| CARR-RESIDENCE GARAGE RECONSTR. | 24827 ROCKLEDGE RICHMOND HTS, OH |

OWNER REDLINE 10/2/26 - R. CHARLES CARR

CHANGES REQUESTED OF ARCHITECT. NOT AN ISSUED OR STAMPED DRAWING.

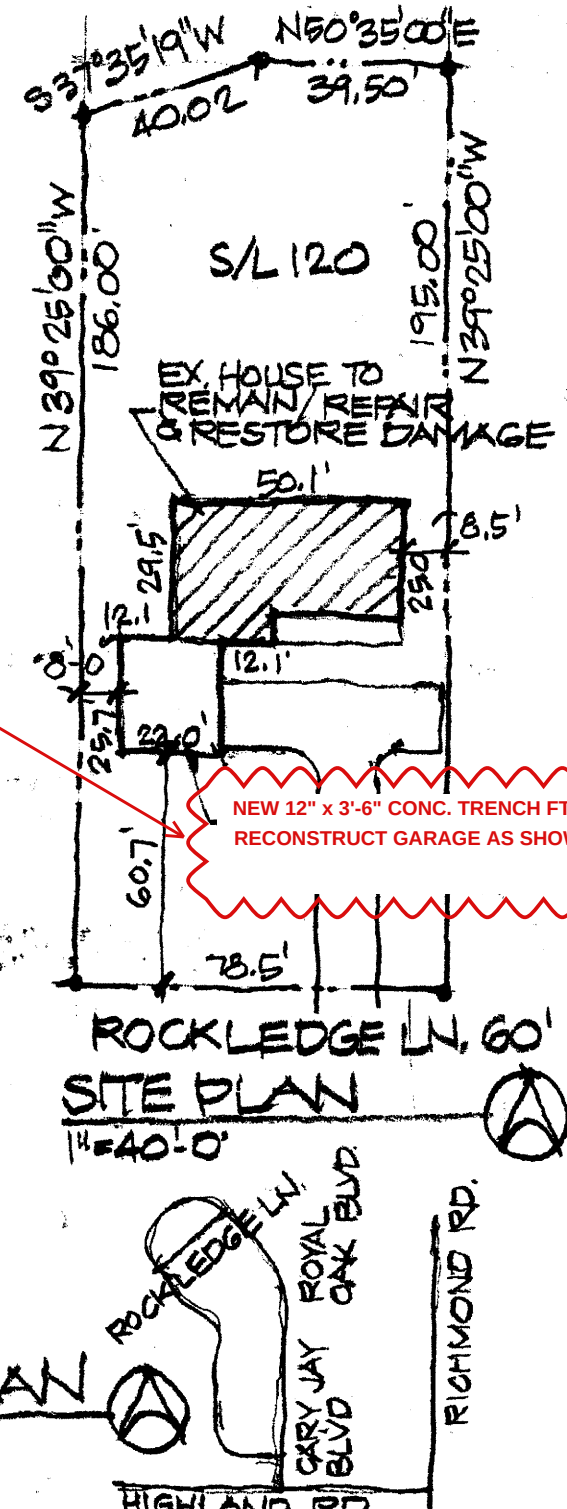
2. SITE PLAN NOTE REVISED TO MATCH A3-A6.

WAS: "EX. GARAGE FNDN TO REMAIN / RECONSTRUCT GARAGE AS SHOWN."

FLOOR PLAN  
1/4\" = 1'-0"

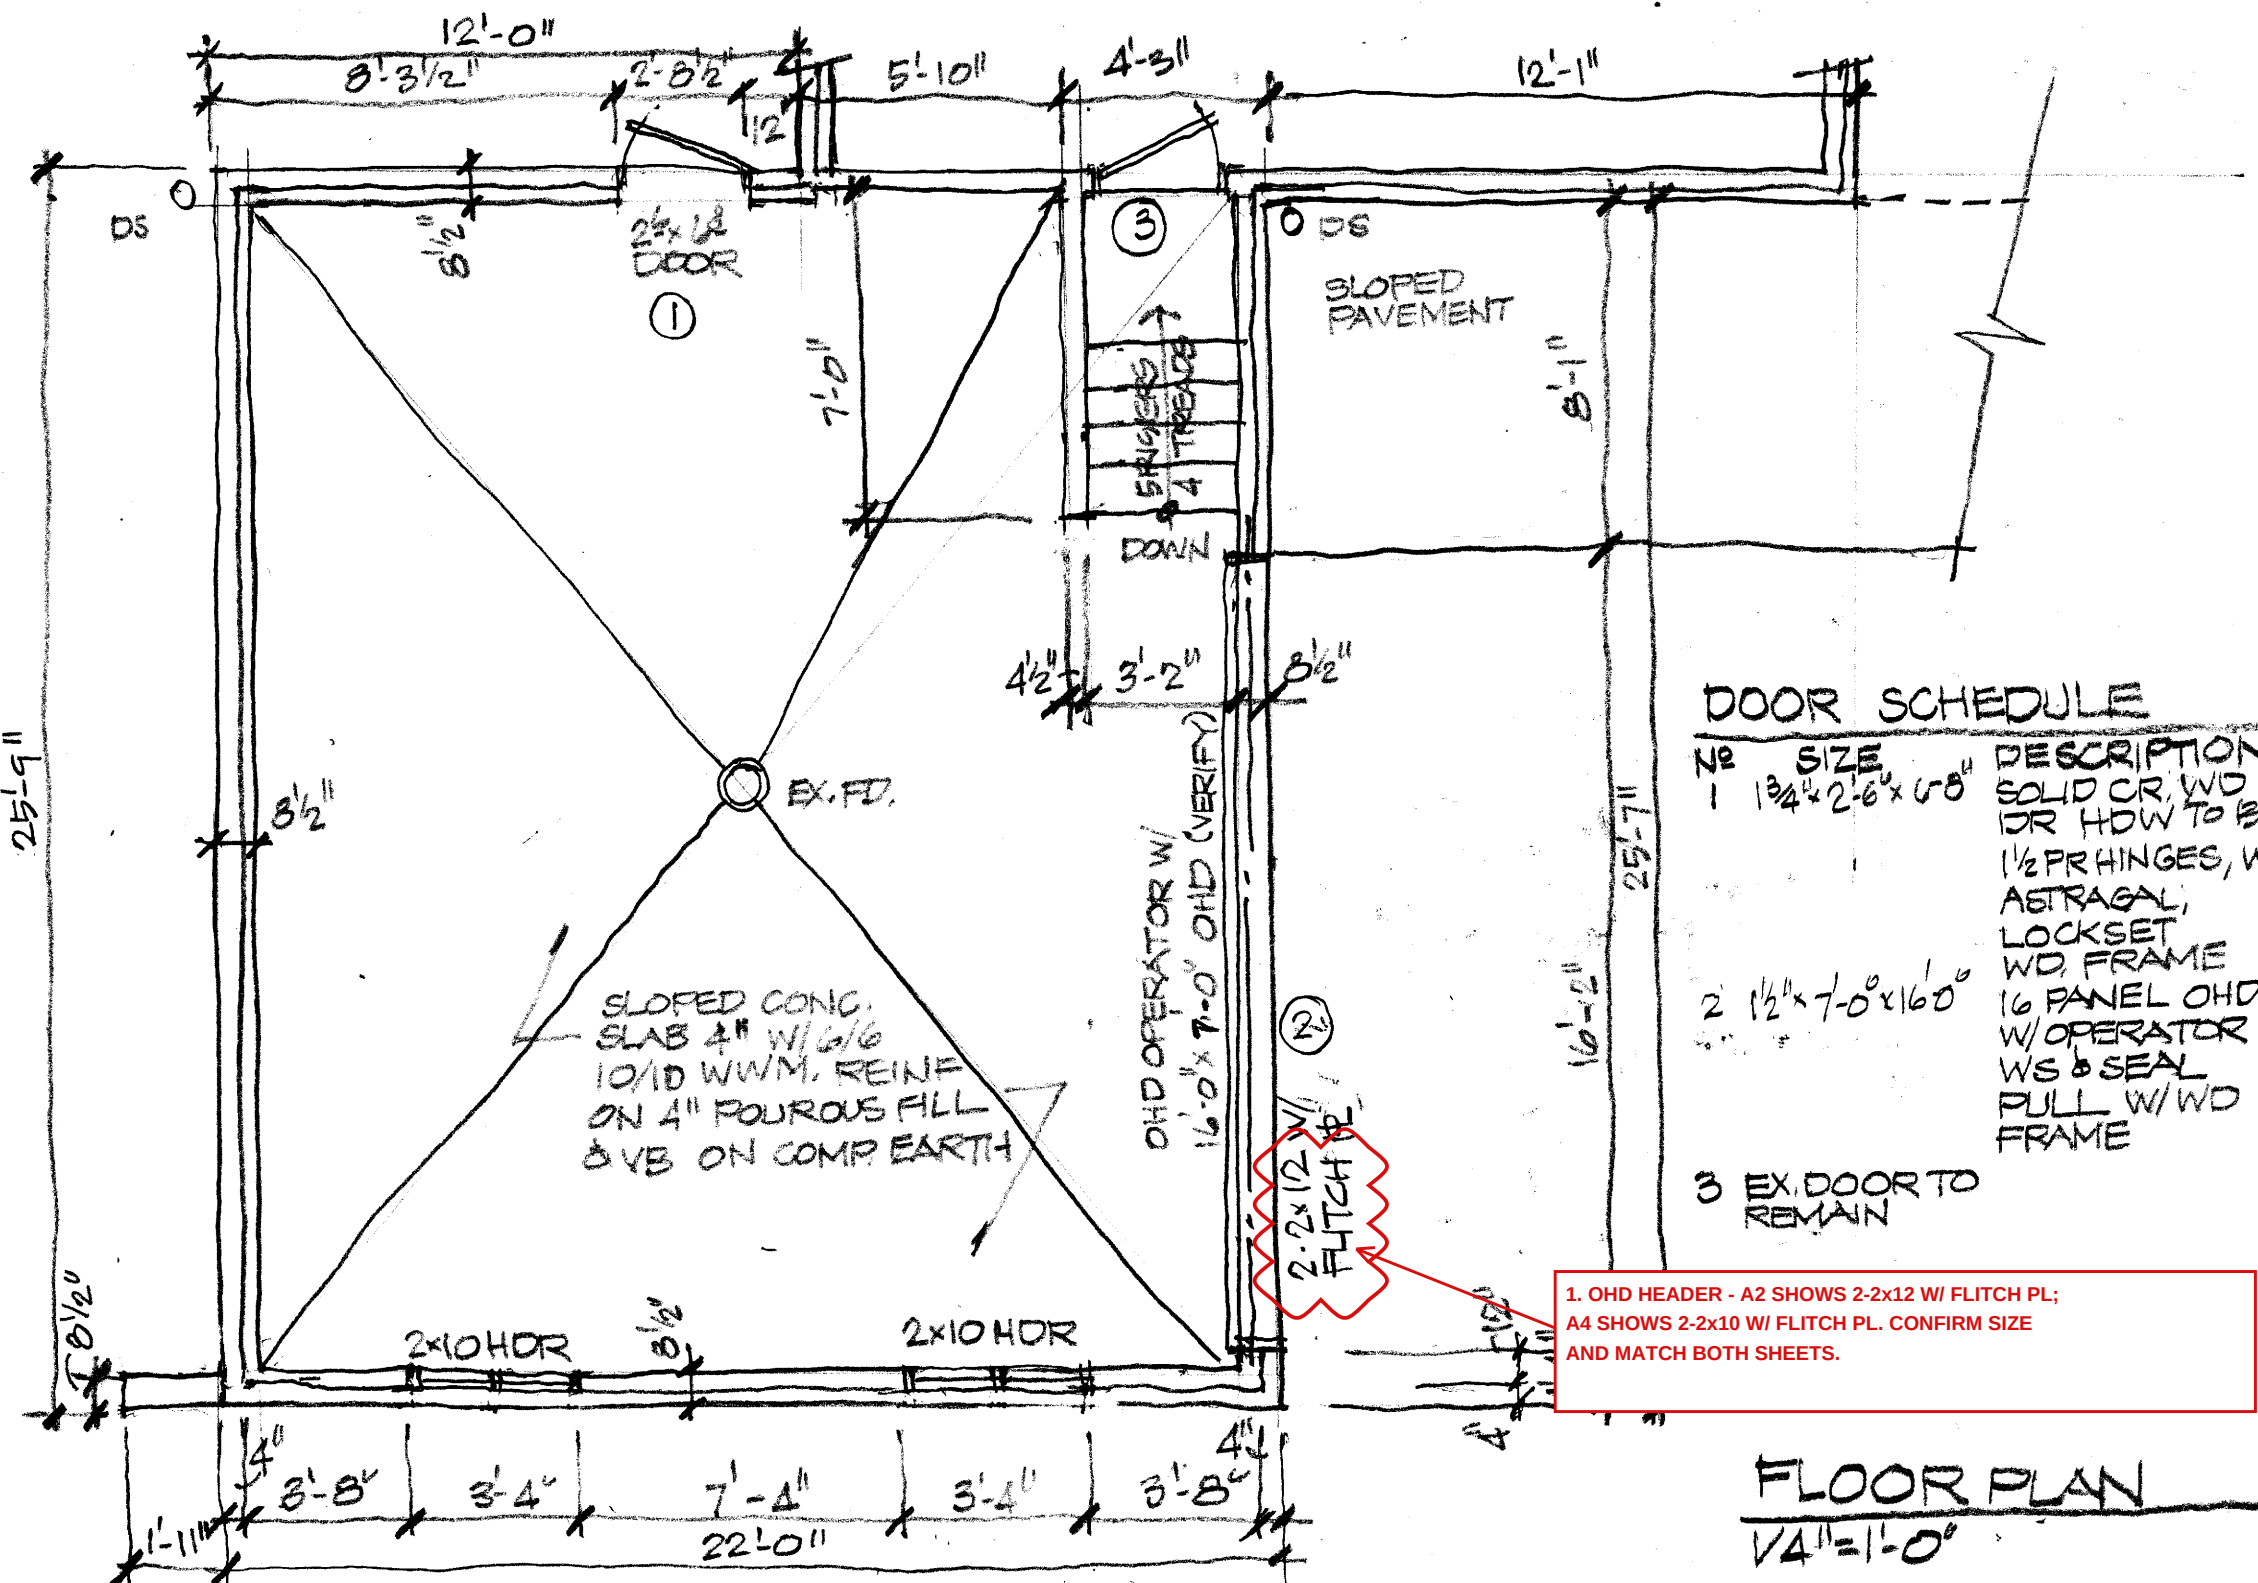
1. OHD HEADER - A2 SHOWS 2-2x12 W/ FLITCH PL;  
A4 SHOWS 2-2x10 W/ FLITCH PL. CONFIRM SIZE  
AND MATCH BOTH SHEETS.

SOUTH ELEVATION  
V4 = 1'-0"

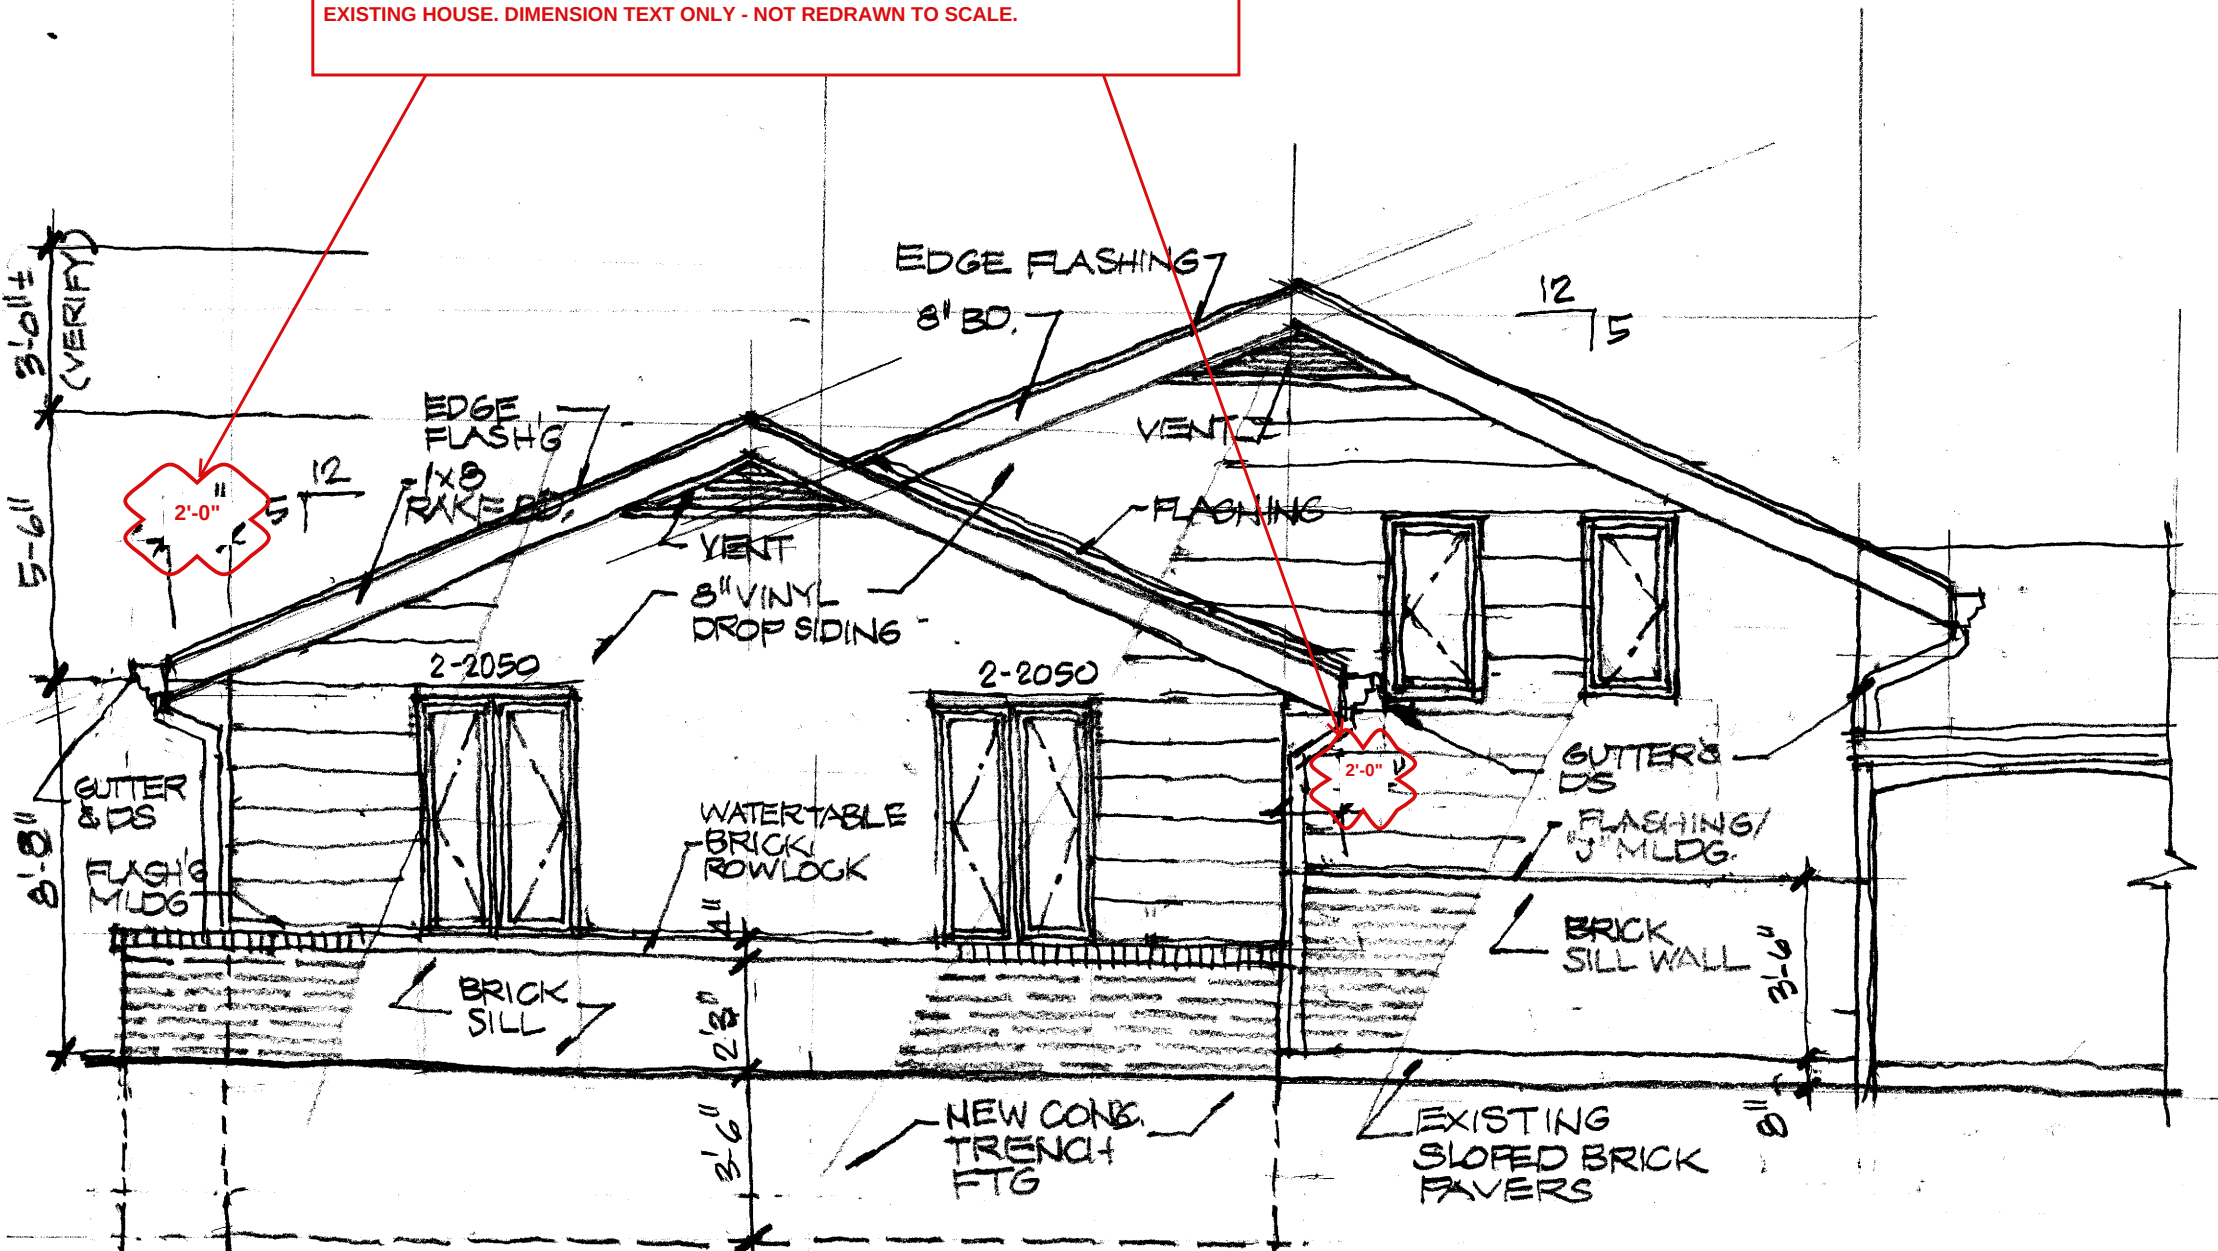
3. OVERHANG REVISED 12" TO 2'-0" ON A3-A6 TO MATCH THE EXISTING HOUSE. DIMENSION TEXT ONLY - NOT REDRAWN TO SCALE.

**EAST ELEVATION**  
1/4" = 1'-0"

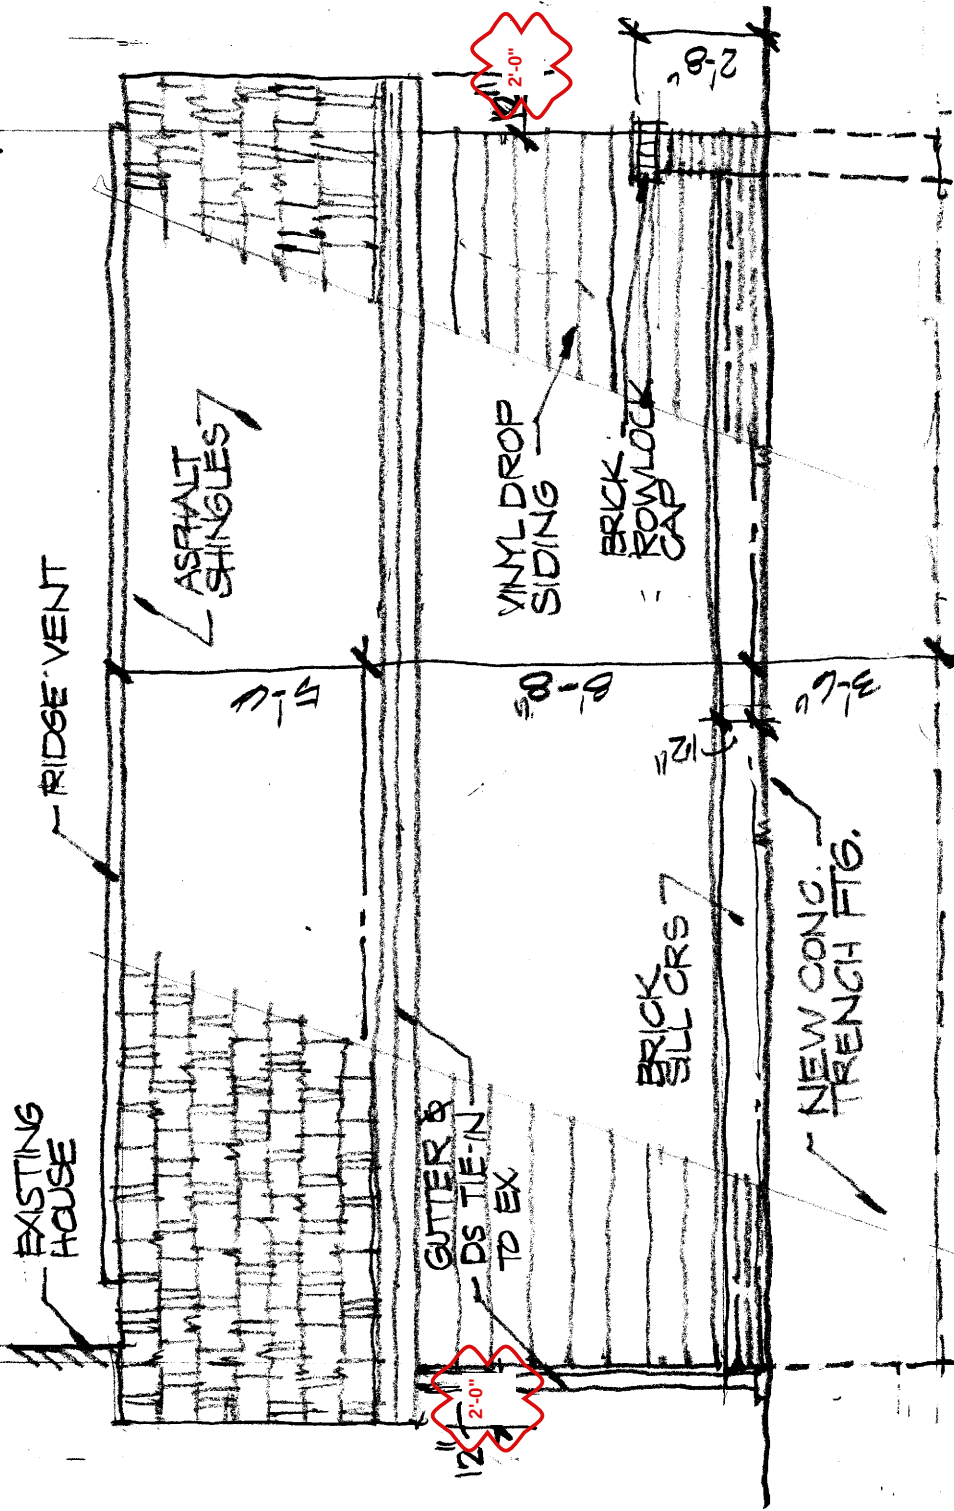
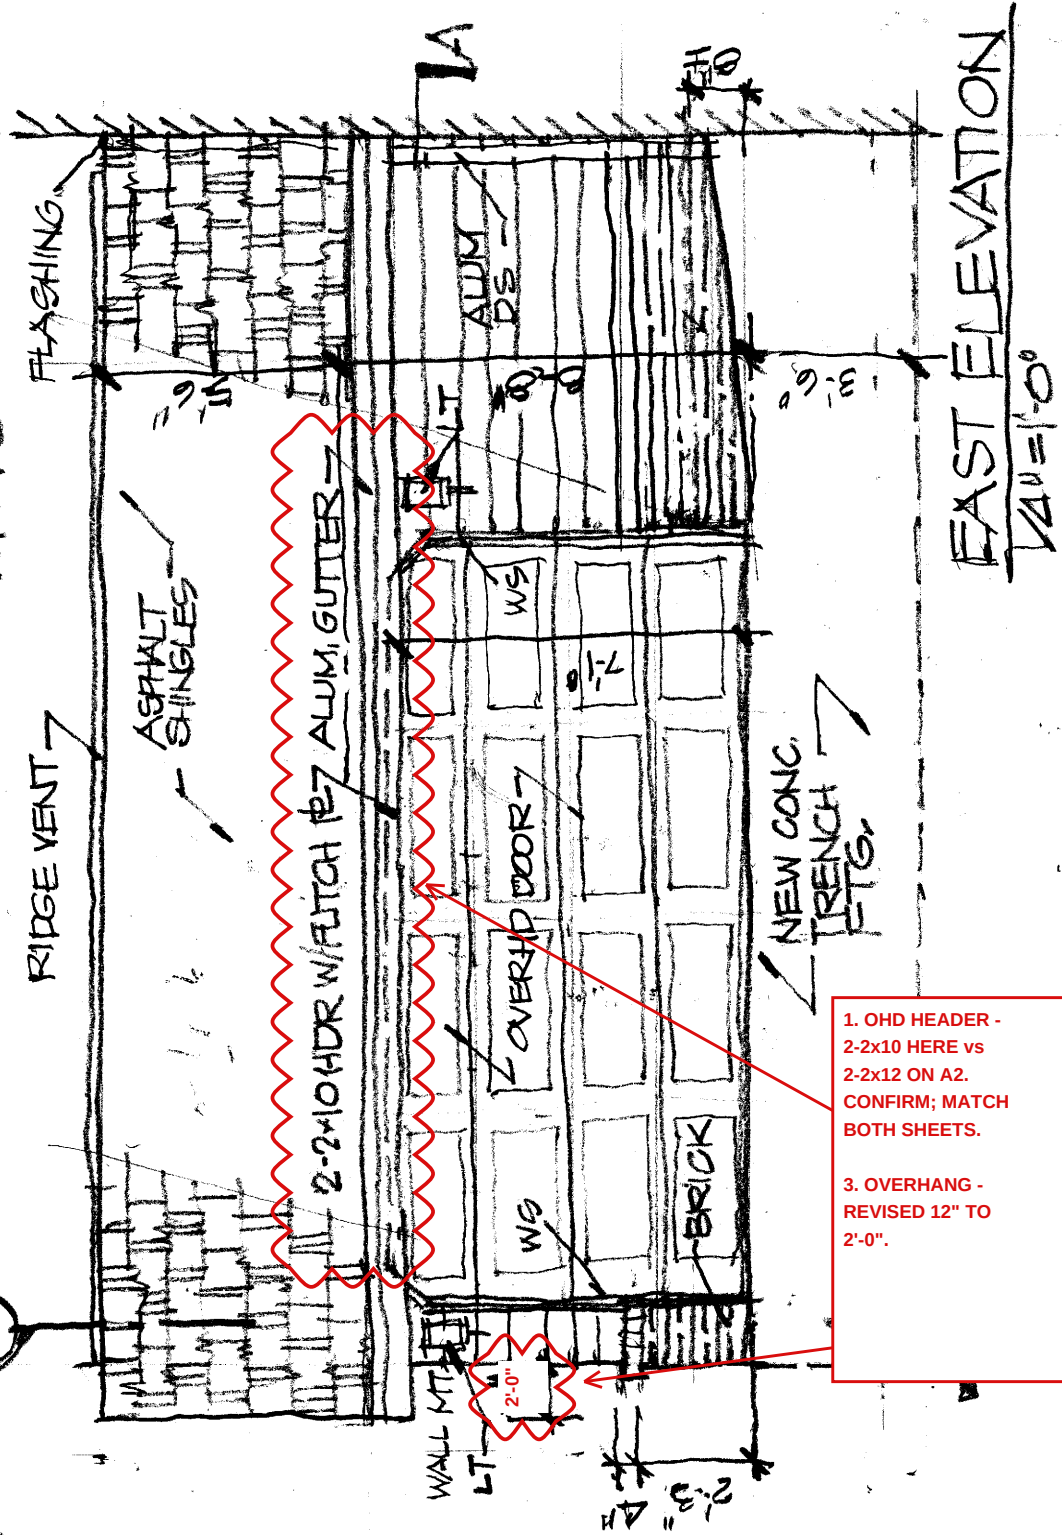
- 1. OHD HEADER - 2-2x10 HERE vs 2-2x12 ON A2. CONFIRM; MATCH BOTH SHEETS.
- 3. OVERHANG - REVISED 12" TO 2'-0".

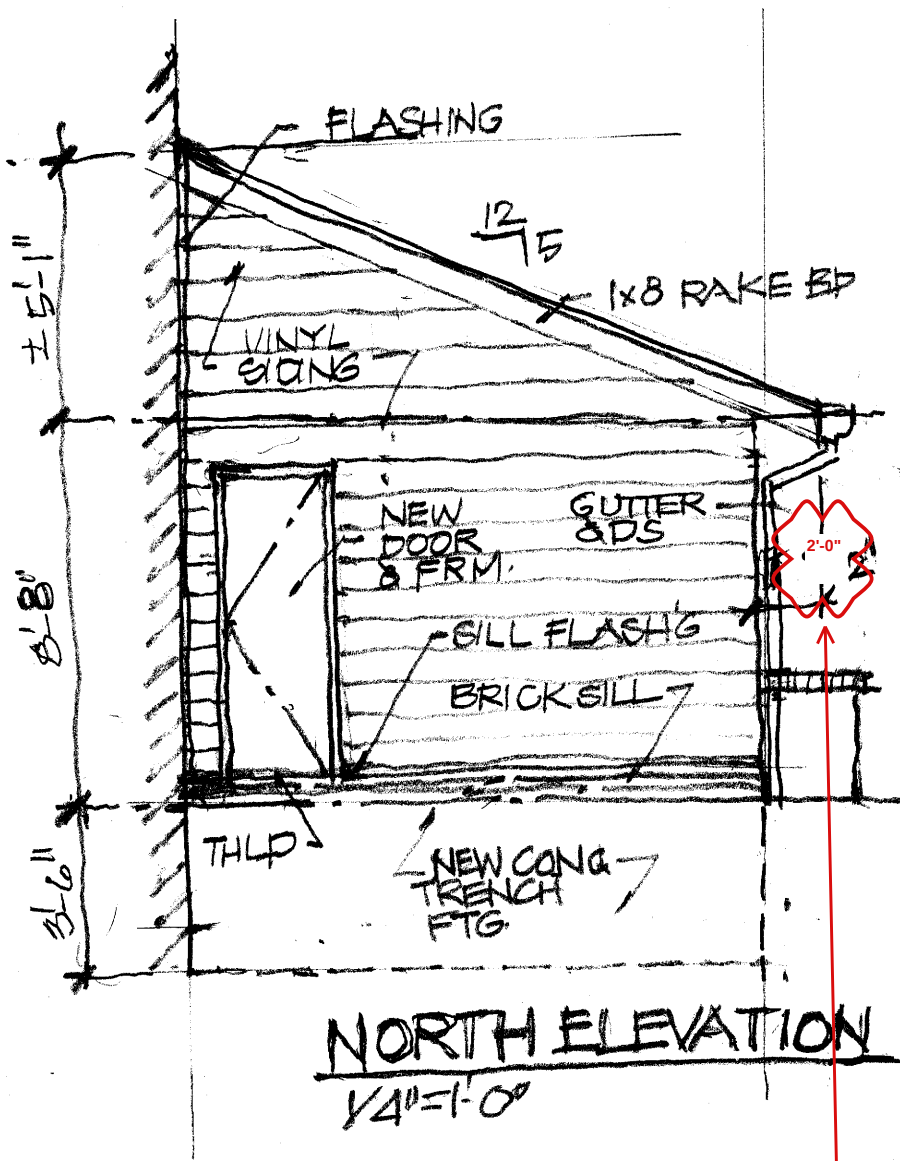
3. OVERHANG REVISED 12" TO 2'-0"  
(NORTH ELEVATION AND SECTION 1).
